REVISED RESPONSE TO REQUEST FOR ADDITIONAL INFORMATION

APR1400 Design Certification

Docket No. 52-046

RAI No.: 248-8295
SRP Section: 03.08.05 - Foundations
Application Section: 3.8.5
Date of RAI Issue: 10/14/2015

Figure 3.8A-56 Reinforcement Arrangement of the West Wall of the EDG Building

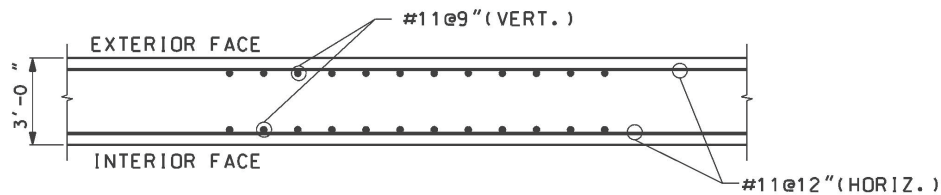
- b. In Section 3.8A.2.4, "Analysis and Design for Critical Sections", the applicant stated, "The locations of critical sections are shown in Figures 3.8A-25 through 3.8A-28 and the location of the concrete frame is shown in Figure 3.8A-53." The staff noticed that figure does not show a concrete frame for the AB, but instead shows several walls of the EDG building. The applicant is requested to provide the appropriate figure.

- b. This is an editorial error since the concrete frame has not been designed for critical sections, as described in Section 3.8A.2.4. Therefore, the associated description in the DCD will be deleted, as shown in Attachment 2 to this response.
- c. In DCD Tier 2, between Table 3.8A-23 and Table 3.8A-24, the information of margin of safety for IRWST structure is missing. Accordingly, Section 3.8A.1.4.3.2.3 will be modified, and Table 3.8A-41 will be added for the missing information, as shown in Attachment 3.

**Figure 3.8-57 Rebar Arrangement of Containment Dome**

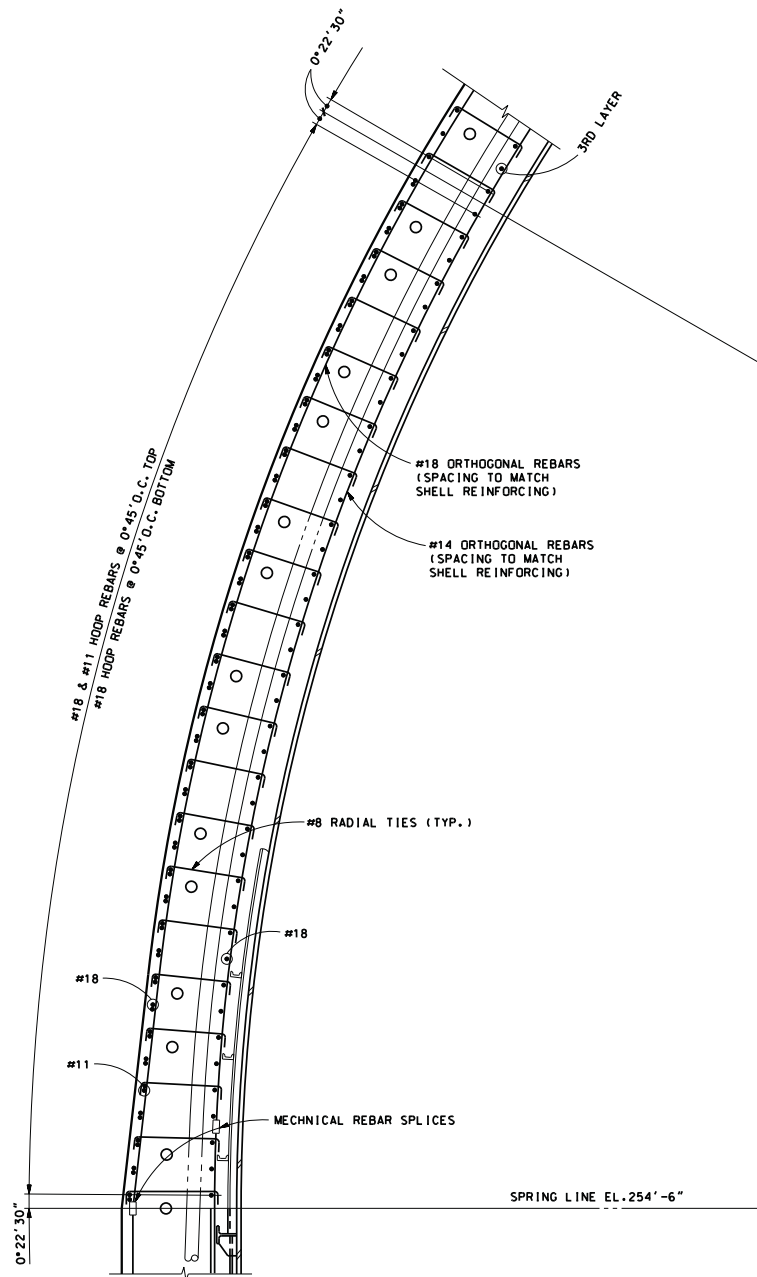
- a. Whether any other critical sections such as the dome; steel plate liner to the containment; floor slab between the SSW and the containment, and a steel beam and/or column; and mainsteam and feedwater penetrations are identified as critical sections. If so, the applicable portion of the DCD should be updated accordingly.

In the list of critical design sections in DCD Tier 2, Section 3.8A.1.4.1.3.5, containment dome and liner plate/anchorage are missing. The design forces and moments, design results, and margin of safety for the containment dome will be added to DCD Tier 2, Sections 3.8A.1.4.1.3.4 through 3.8A.1.4.1.3.7, and the corresponding figures and tables, as shown in Attachment 1 to this response. For the containment liner plate and anchorage, the design procedure and criteria are described in Section 3.8.1.4.10. The design results, including the margin of safety, are presented in Table 3.8-12 in the DCD. A more detailed description of the design approach, procedure, and criteria will be expanded upon in DCD Tier 2, Section 3.8A.1.4.1.3.8, as shown in Attachment 1 to this response.

3.8A.1.4.3.4, Tables 3.8A-41 through 3.8A-46, and Figure 3.8A-57 will be also added for additional information.

The containment dome is also reinforced by two-way orthogonal sets of vertical reinforcing steel and hoop reinforcing steel. The orthogonal reinforcing is the continuation of the vertical reinforcing in the containment wall. Hoop reinforcing is also provided up to 45 degrees above the springline. Radial reinforcements are provided over the entire dome to resist radial tension forces resulting from curved tendons.
